**FINDINGS AND RECOMMENDATION
OFFICE OF PLANNING AND ZONING
ANNE ARUNDEL COUNTY, MARYLAND**

CASE NUMBER: 2023-0131-V

REQUEST

VARIANCE PLAN FOR 1724 WESTMORELAND TRL

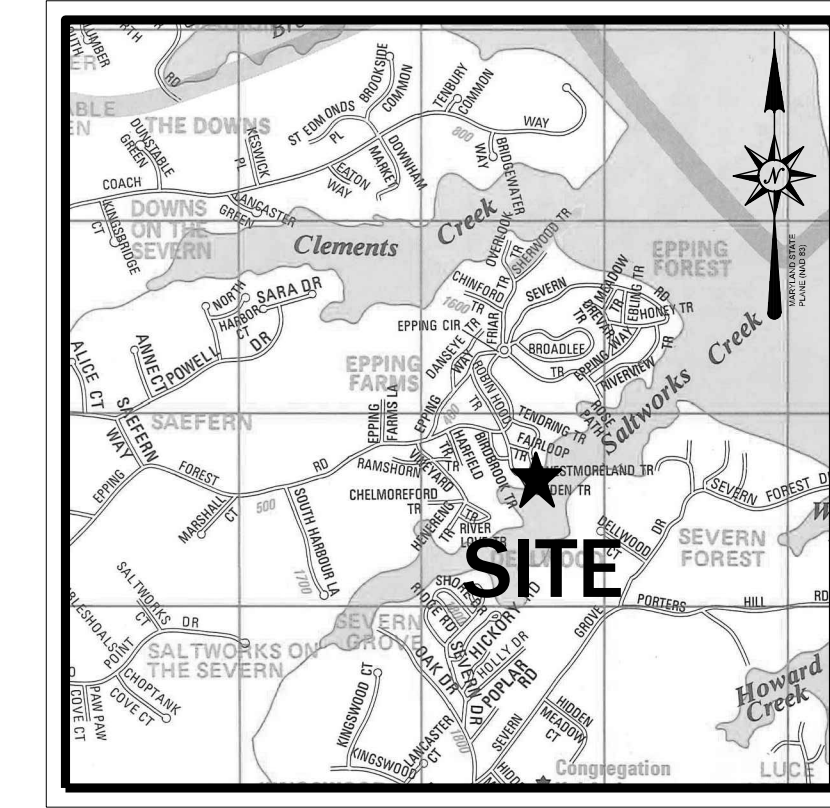
The **Critical Area Team** offers no objection to the replacement of the existing structure and deck. The site plans are unclear with regard to the proposed construction along the waterside of the dwelling. The deck should not be expanded into the steep slopes. Mitigation will be determined at permit. A modification will be required.

Engineering advised that no SWM ESD practices may be located in any environmentally sensitive areas or their buffers. If indeed the site is buffer and not modified, no SWM practices may be in the 100 buffer. The entire site is steep slope and buffer. shaded as 25% slopes, therefore there is no area to provide SWM.

Critical Area Team advised Per correspondence with the Health Department, although recommendations were made in May 2021, a site plan for the addition has not been submitted and the application is still pending. Every effort should be made to locate/design the system to minimize disturbance to the onsite slopes including locating the system on the roadside if possible. Expansion of the footprint or decks that results in additional permanent slope disturbance will not be supported. The LOD that will be established for temporary disturbance during demolition is not intended to open that area for, construction/grading.

Zoning requests house and deck dimensions be labeled, also indicate number of stories. New dwelling offers opportunity to comply with side lot line setbacks. Need to justify. Please provide floor plan if possible.

Based upon the standards set forth in § 18-16-305 of the County Code under which a variance may be granted, as proposed, this Office recommends ***approval*** of zoning variances to §18-4-501 to allow a principal structure as close as 5 feet from the west side property line, as close as 9 feet

from the northeast side property line, and 14 feet combined; and ***approval*** of the Critical Area variance to § 17-8-201(a) to disturb steep slopes. The final amount of disturbance will be determined during permit review.
